**SSD-52861709 – Multi-Level Warehouse development at 92-116 Gow Street, Padstow
Submission to the Environmental Impact Statement – Canterbury Bankstown City
Council**

Attachment A – Council’s comments for State Significant Development Application SSD-52861709

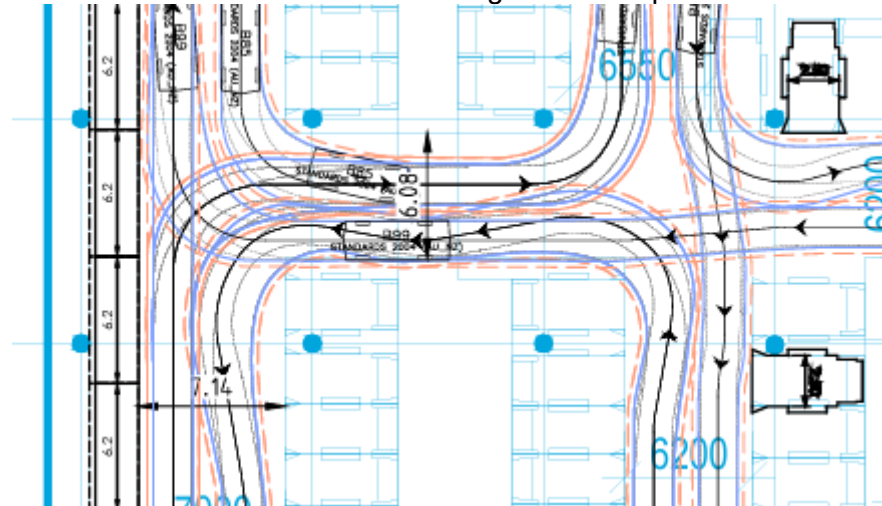
2) Internal Manoeuvrability

- a. There are a number of impractical turning paths within the site. Please refer to Attachment B.
- b. Turning paths for B85 vehicles are to be shown on a separate drawing for clear assessment. The below drawing is not acceptable.
